City of Portland, Maine - Building or Use Permit Application

Current use: Vacant property, former battery foundation
If the location is currently vacant, what was prior use:
Approximately how long has it been vacant:
Proposed use: Single family home
Project description: Pereira Cottage at Battery Cravens

**CITY OF PORTLAND, ME
BOCA 1999 Plan Review Record
One and Two Family Dwelling**

BUILDING PERMIT REPORT

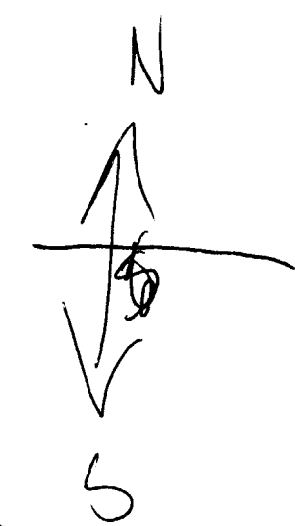
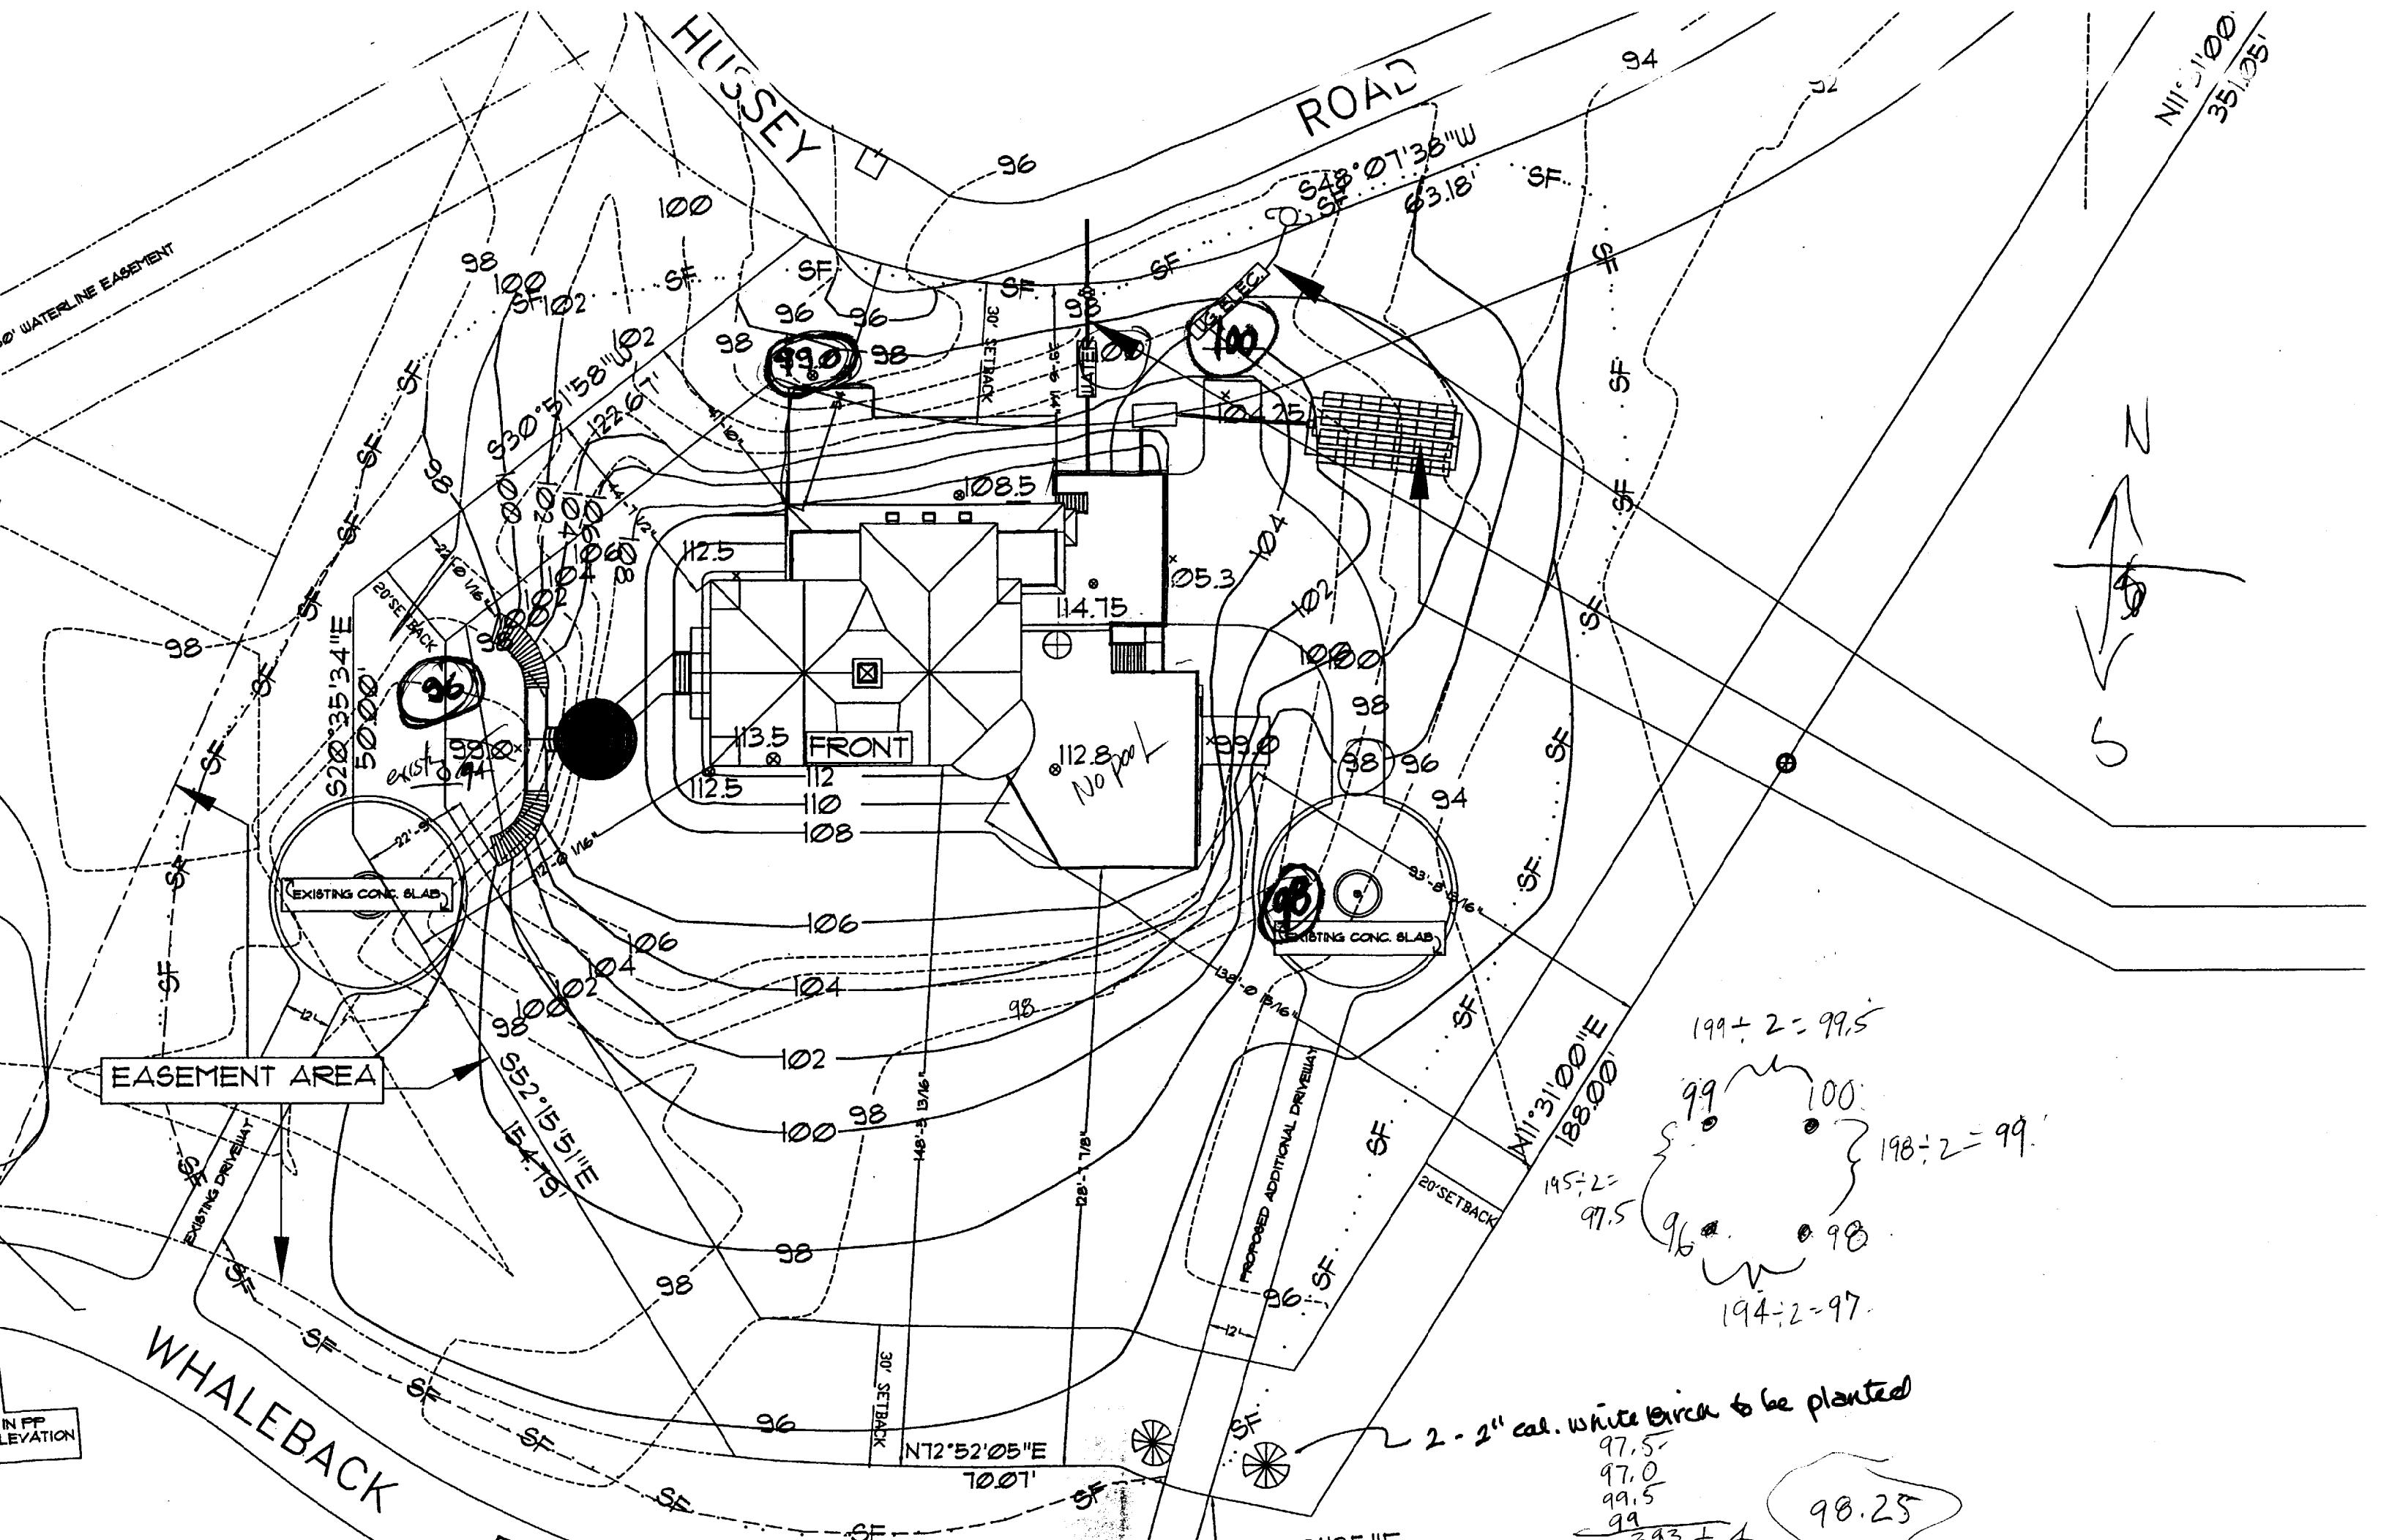
5/25/01
revised plans
to meet
35' height

34.92 = 35' is max height

SITE PLAN

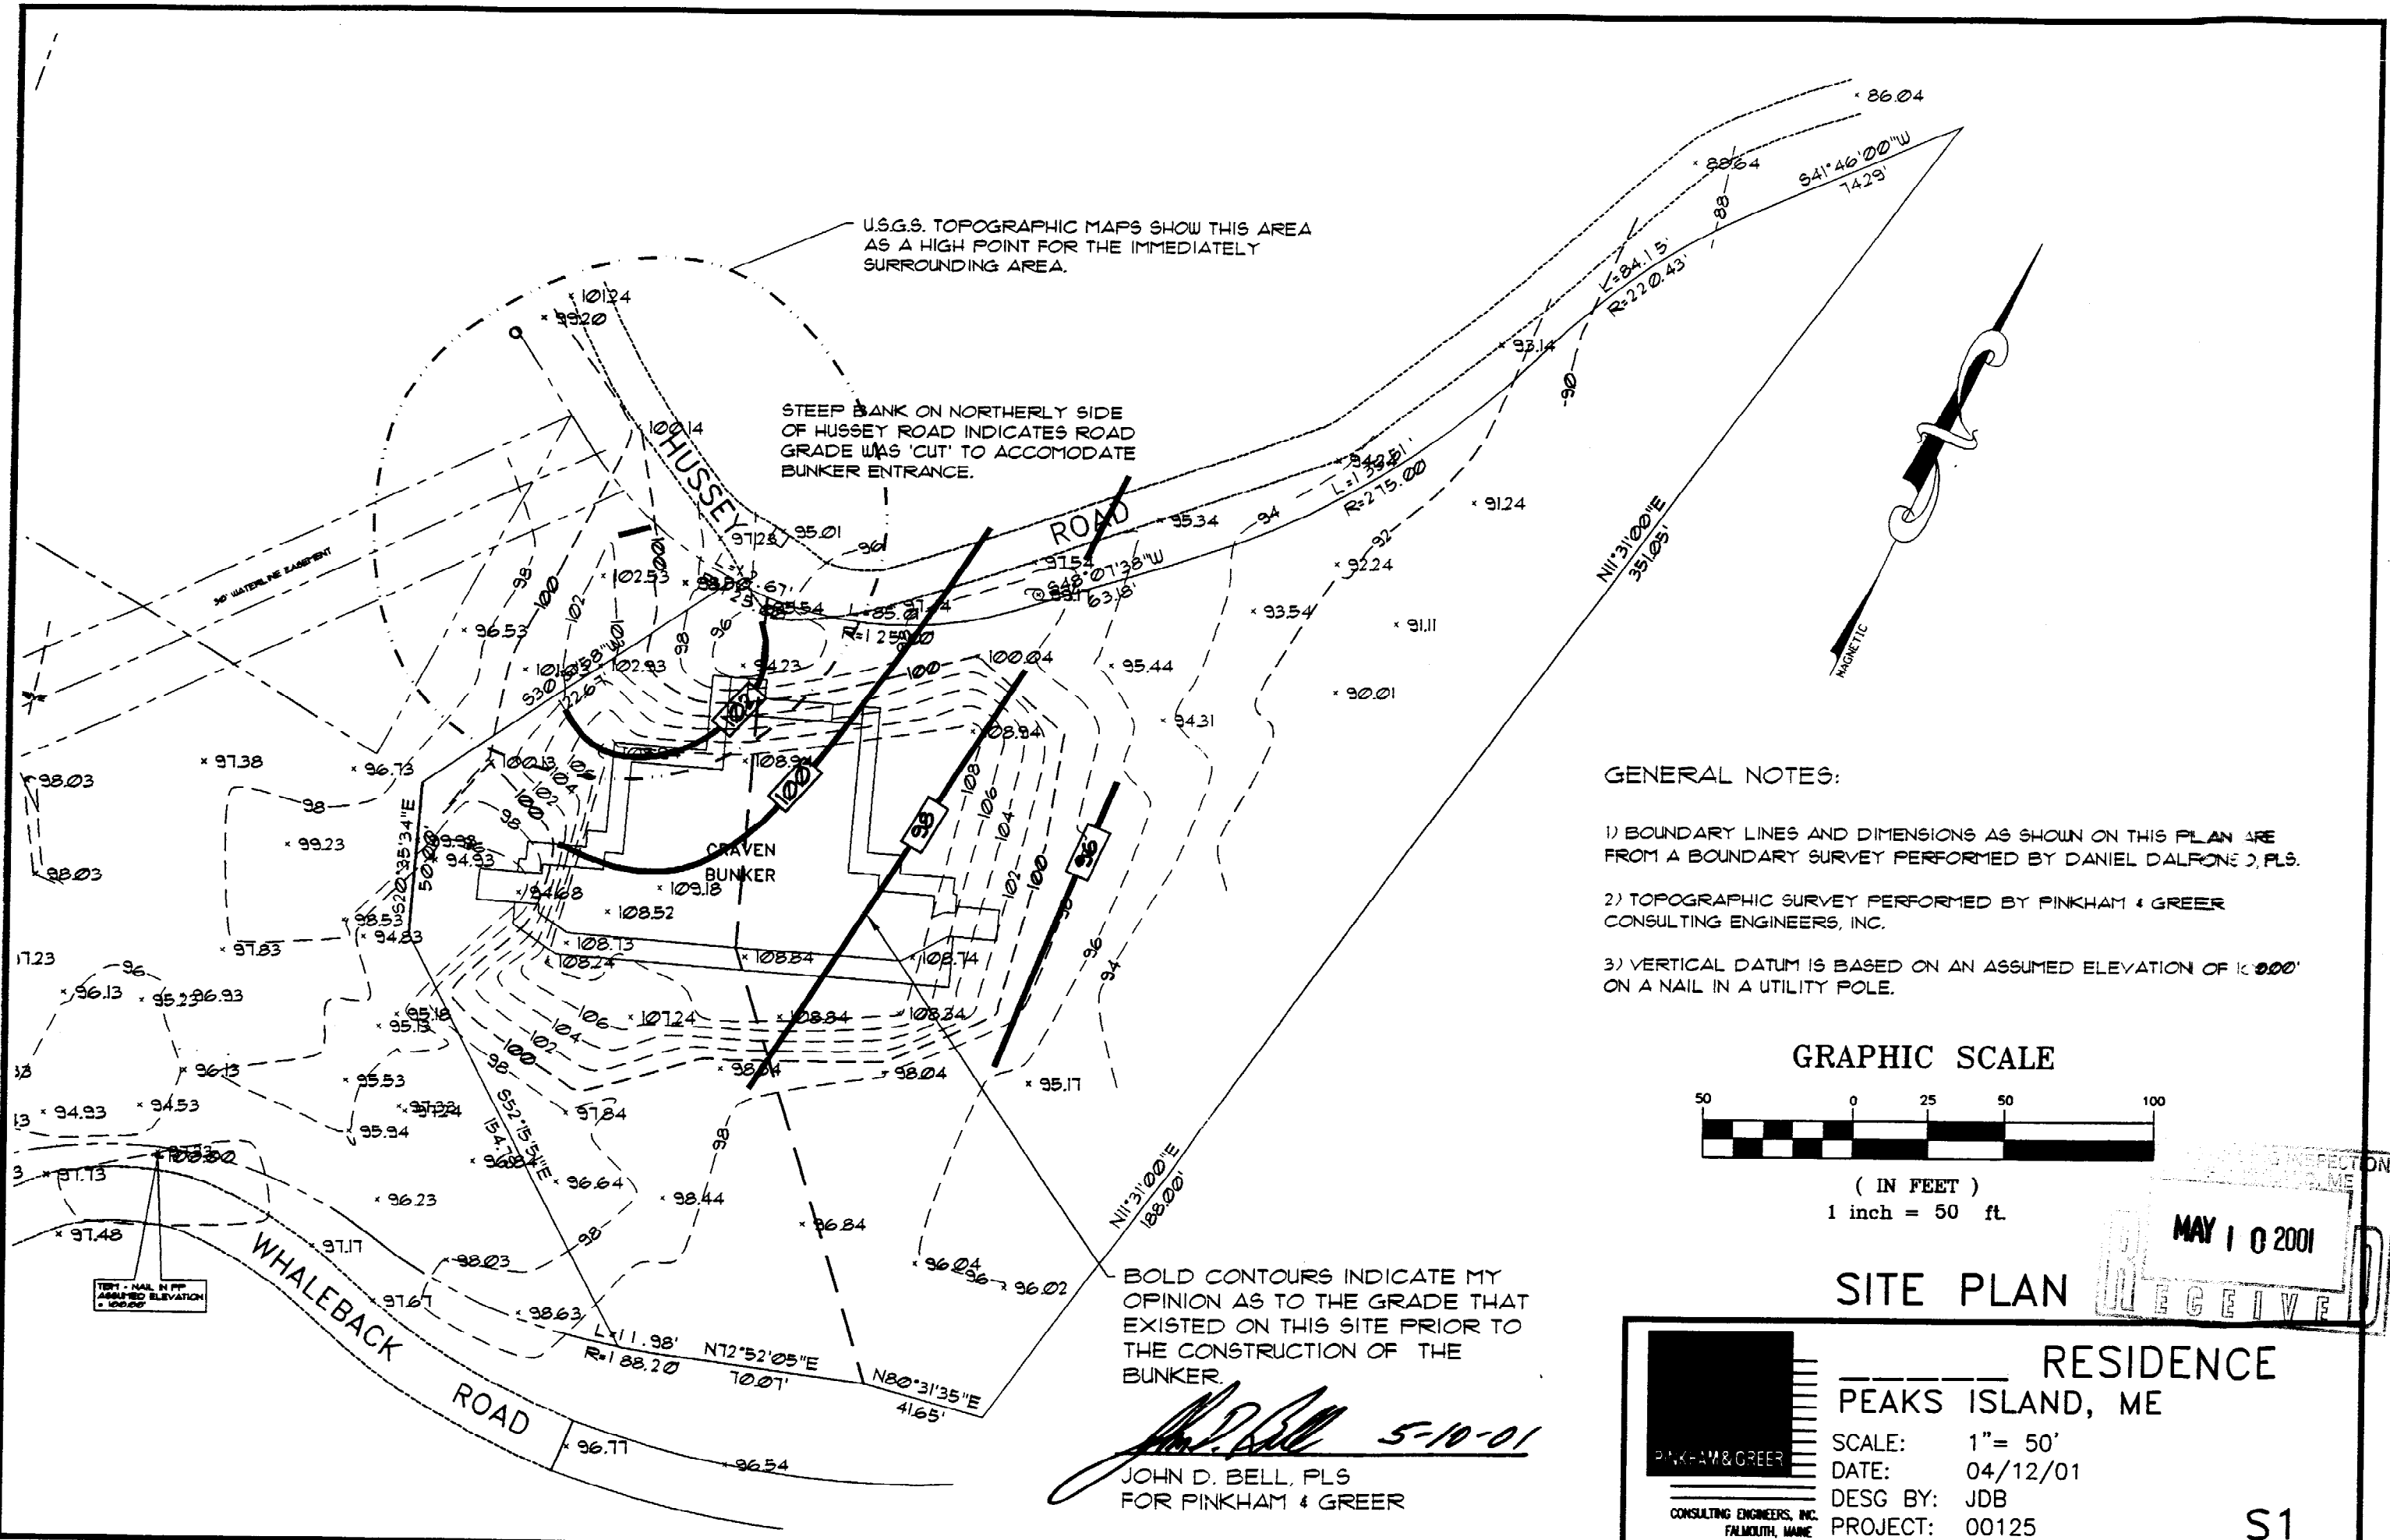
U.S.G.S. TOPOGRAPHIC MAPS SHOW THIS AREA AS A HIGH POINT FOR THE IMMEDIATELY SURROUNDING AREA.

STEEP BANK ON NORTHERLY SIDE OF HUSSEY ROAD INDICATES ROAD GRADE WAS 'CUT' TO ACCOMODATE BUNKER ENTRANCE.
